Replacing an Anden A710 with a Anden A711

DEHUMIDIFIER CONTROL

OVERVIEW

CONTROL WIRING

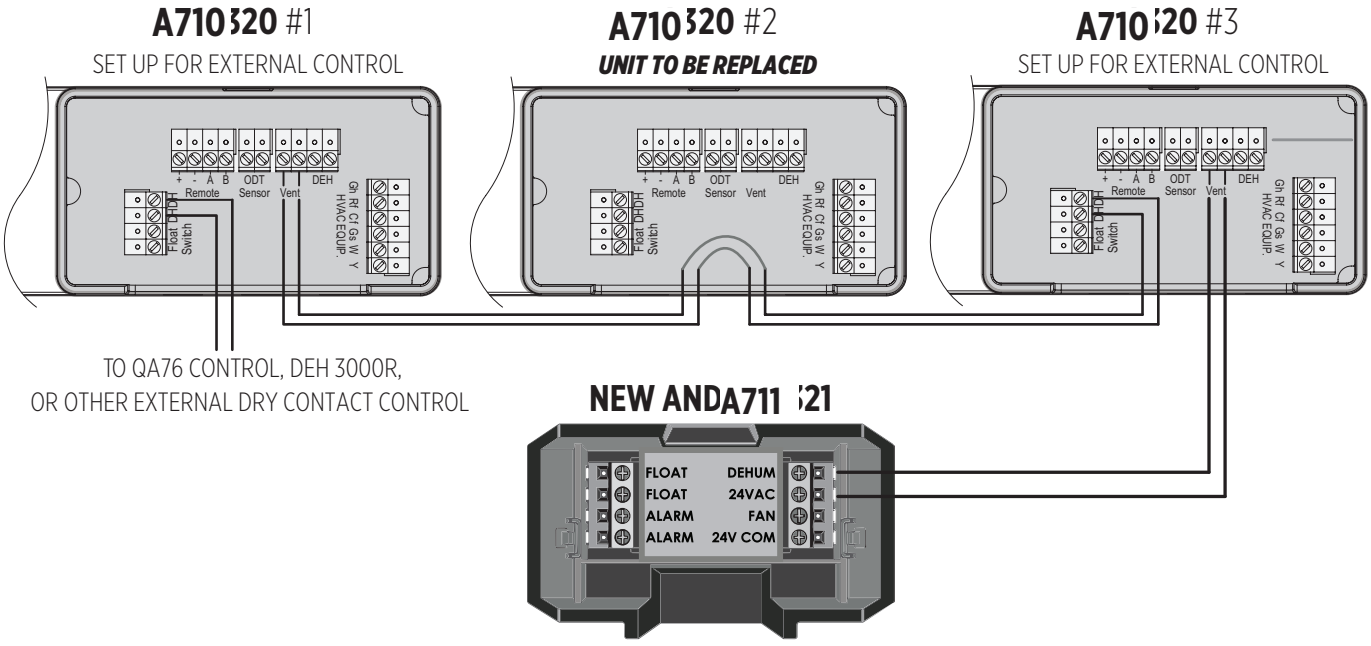
The on-board control for the A711 uses a different wiring configuration and control voltage than the A710. Rewiring of any daisy chained units will be needed.

- A711 cannot be the first or middle unit on the chain. Must be at the end of the chain as shown.
- Additional A711's can be added at the end of the chain using the DEHUM and 24V Com terminals.
- Do not carry over the 24VAC terminal on subsequent A711's

DRAIN TRAP

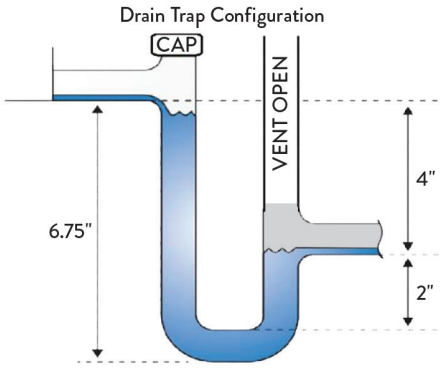
The Anden A711 does not come with a drain trap like the Anden A710 but still requires a trap for best operation. Using the Anden A710 trap on the Anden A711 is possible with some pipe modifications.

A drain trap is recommended upon installation. Condensate drains by gravity via the drain port. Use 3/4" male NPT PVC pipe. An optional condensate pump kit may be installed if a lift is required to dispose of the condensate.

- H: 4"
- J: 2"
- L: 6.75"

- Place vent after the trap.
- Vent should be open.
- Height of vent should be higher than drain outlet.

- A clean out can be placed before trap but must be sealed with a cap.

- Drain line should go in a downward slope toward the drain.
- 1/4" drop her foot.

HANGING METHOD

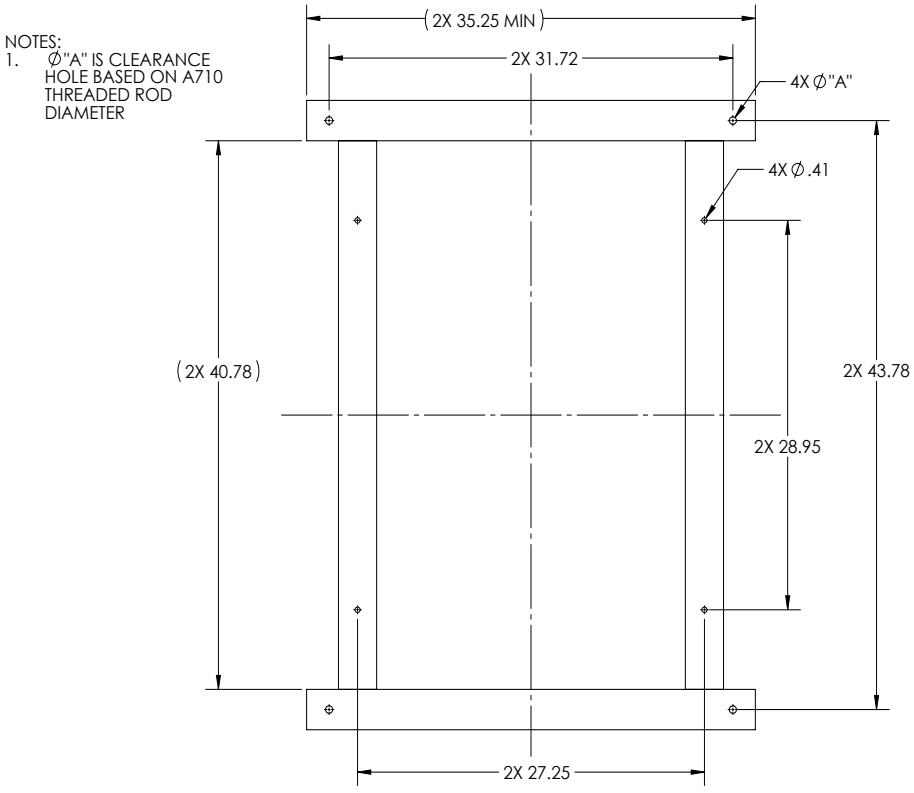
The Aden A710 and A711 have different mounting locations for hanging the unit. Use 2 pieces of Unistrut to adapt the Anden A710's location to the Anden A711.
